To	From	Page 1 of 1
DISTRIBUTION	G.J. Gauck	Date February 21, 1995
Project Title/Work Order		EDT No. 610852
CLOSED OUT TANK 241-SY-101 DACS SYSTEM CHANGE REQUESTS #301-400.		ECN No.

Document Number:	WHC-SD-WM-CMD-004, REV 0
Document Title:	CLOSED OUT TANK 241-SY-101 DACS SYSTEM CHANGE REQUEST #301-400
Release Date:	3/14/95

This document provides a record closed out System Change Request #301-400 used during the development of the 241-SY-101 Hydrogen Mitigation Project Data Acquisition Control System.

HYDROGEN MITIGATION TEST PROJECT
System Change Request Status

SCR #364, SHEET 4 of 6

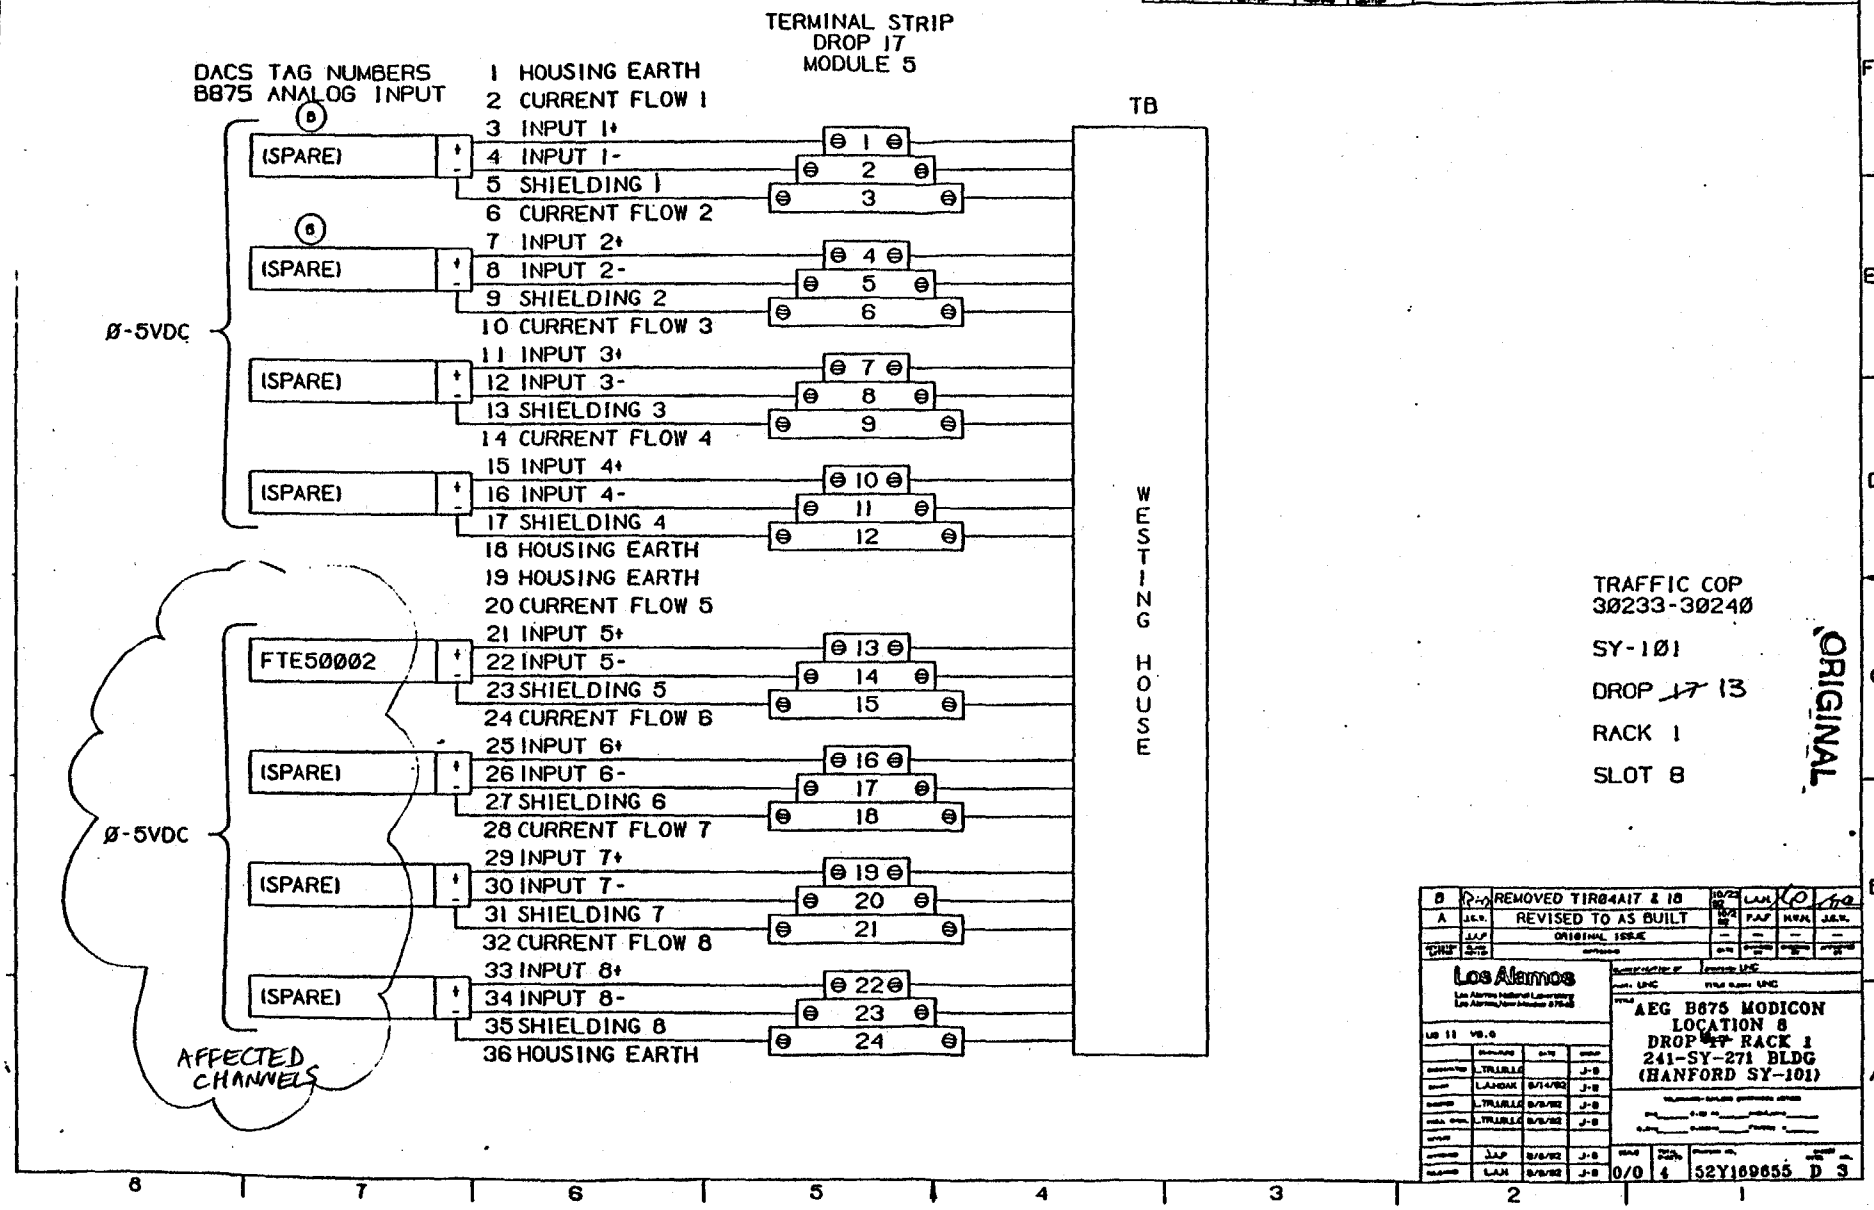
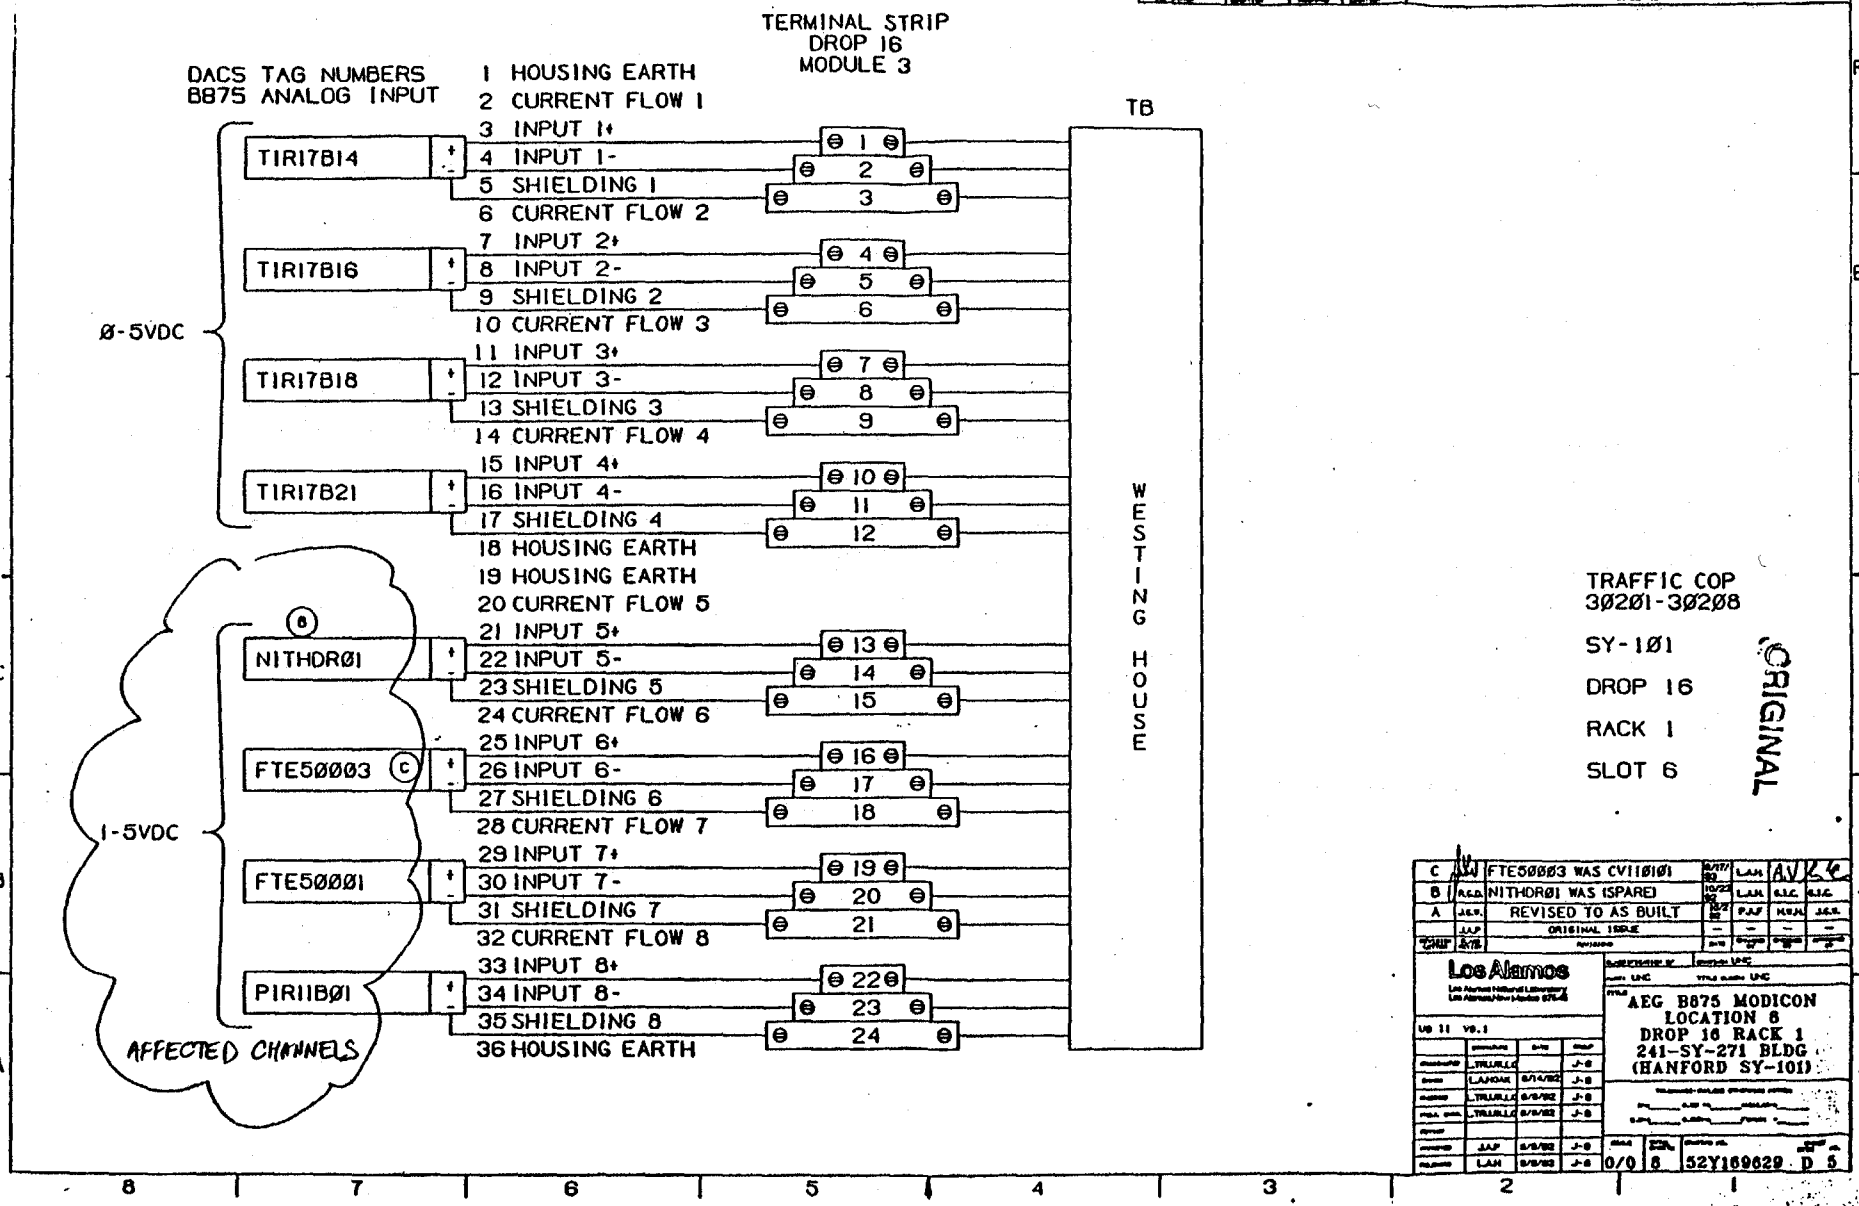
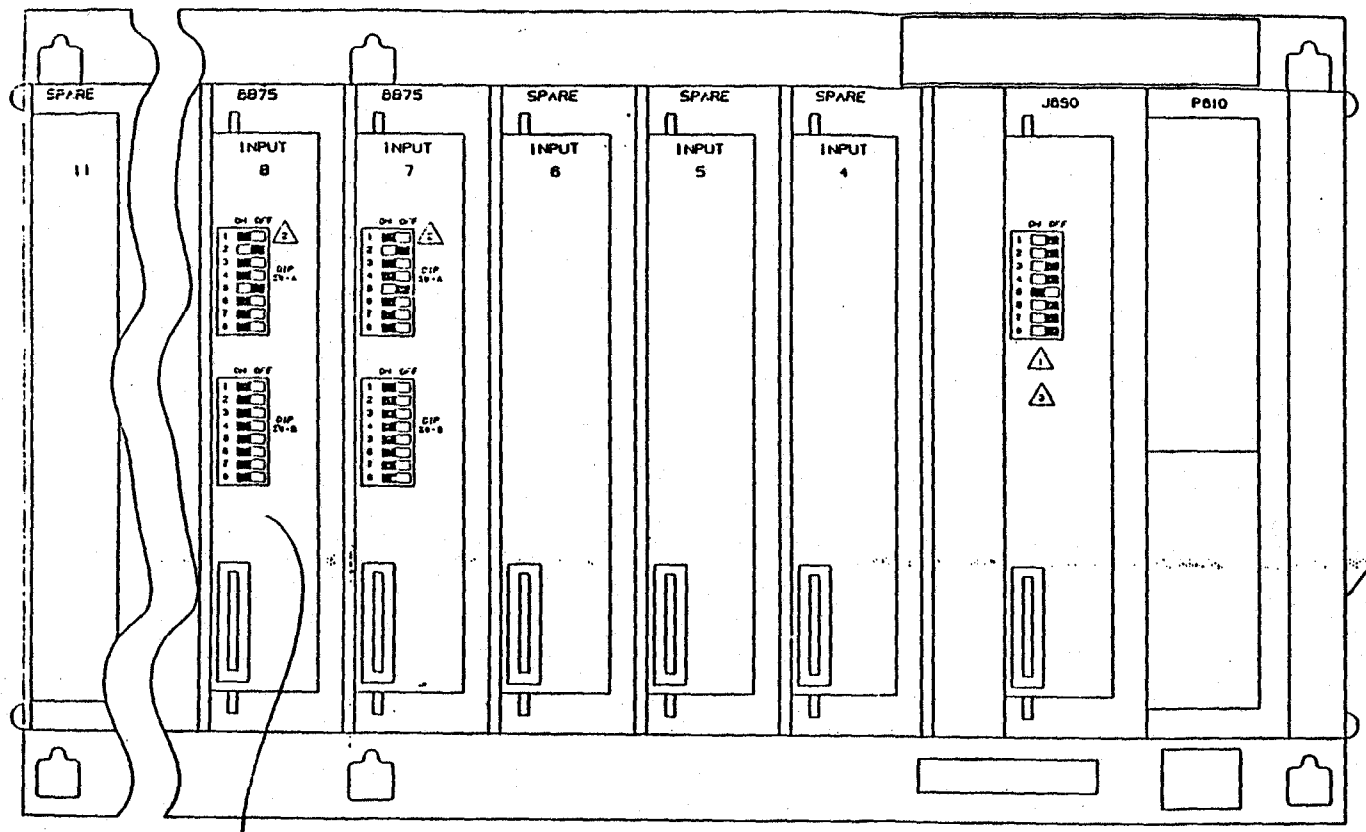
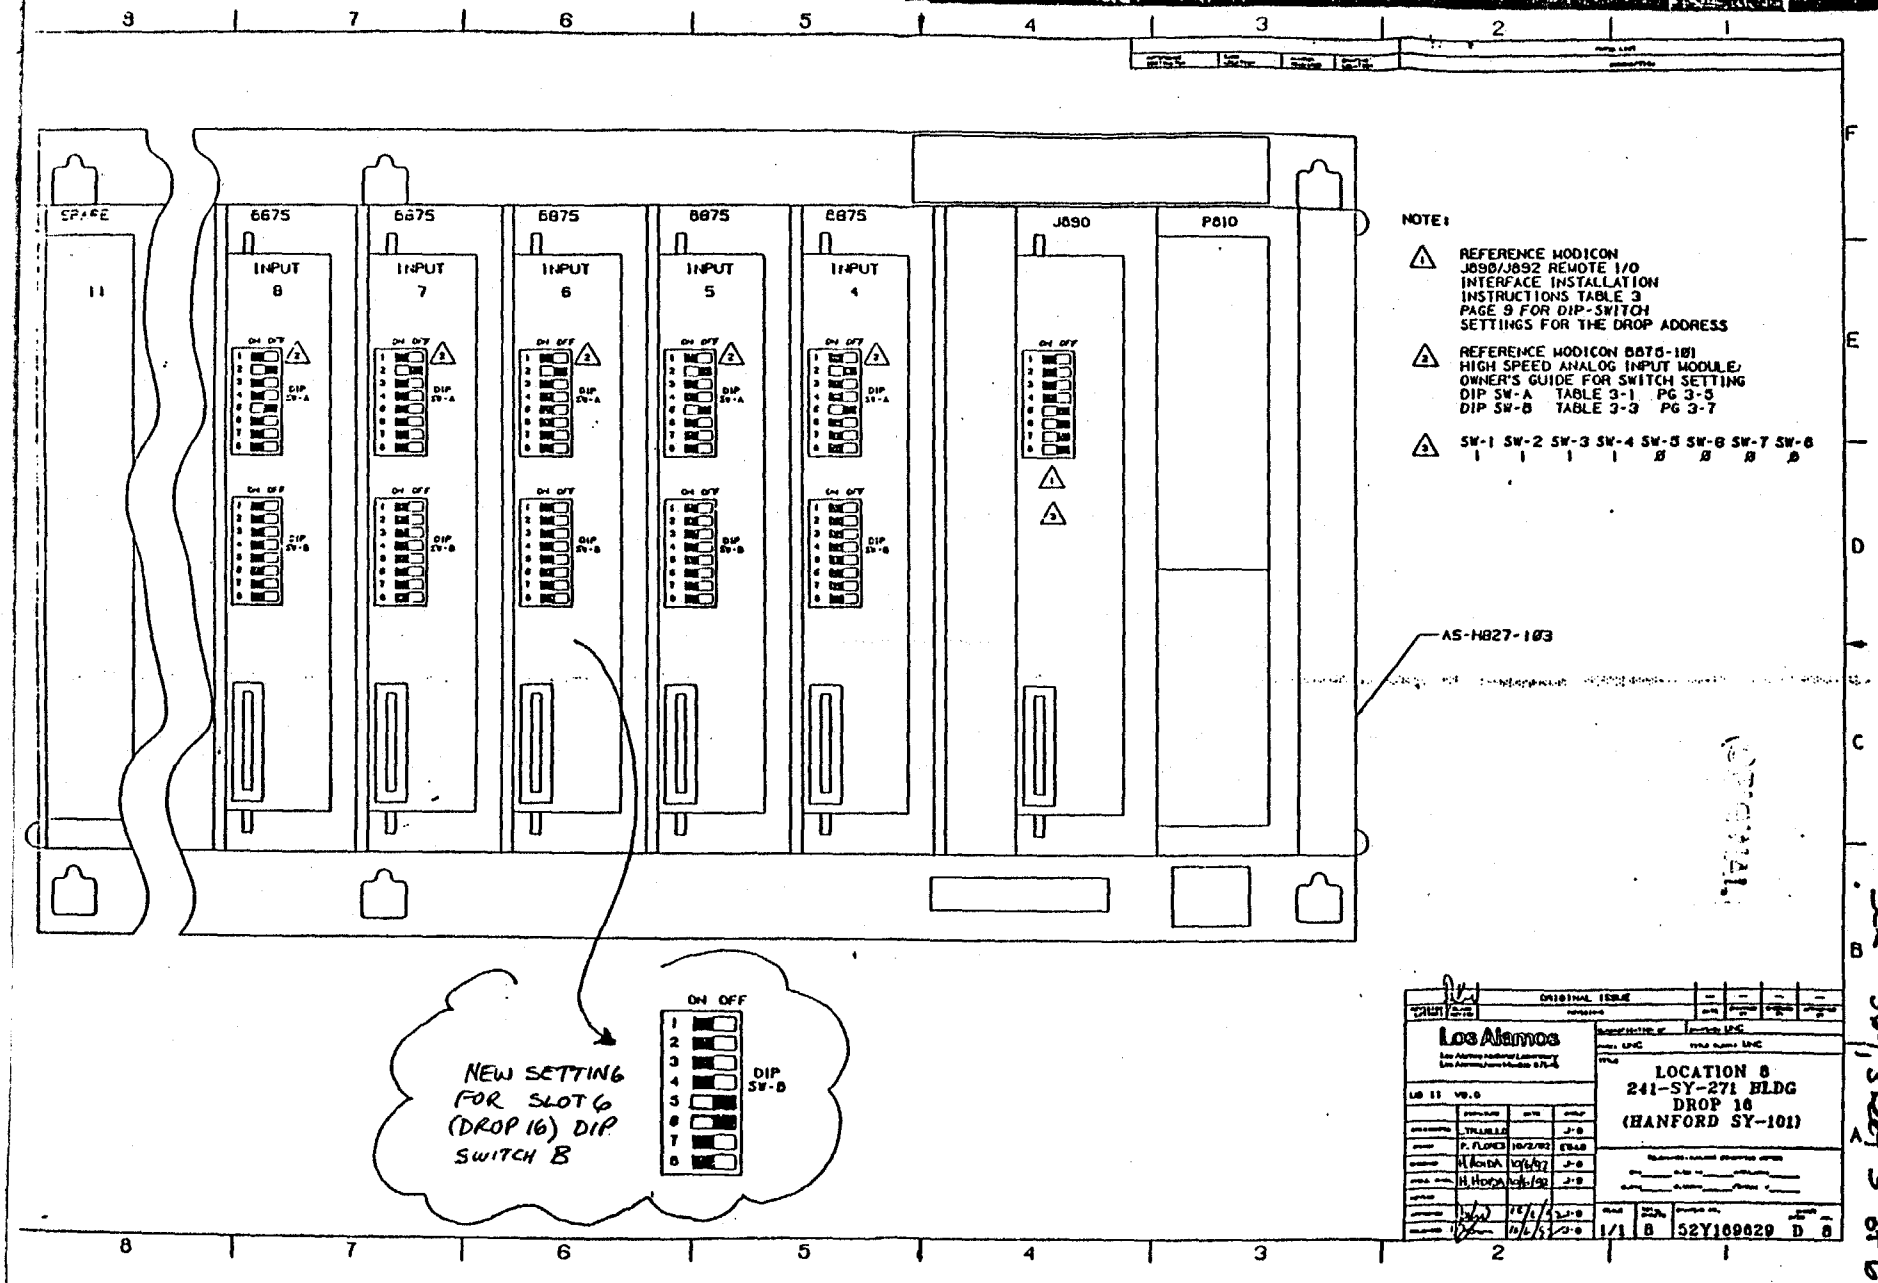
NOTE:

1. REFERENCE MODICON J890/J892 REMOTE I/O INTERFACE INSTALLATION INSTRUCTIONS TABLE 3 PAGE 9 FOR DIP-SWITCH SETTINGS FOR THE DROP ADDRESS
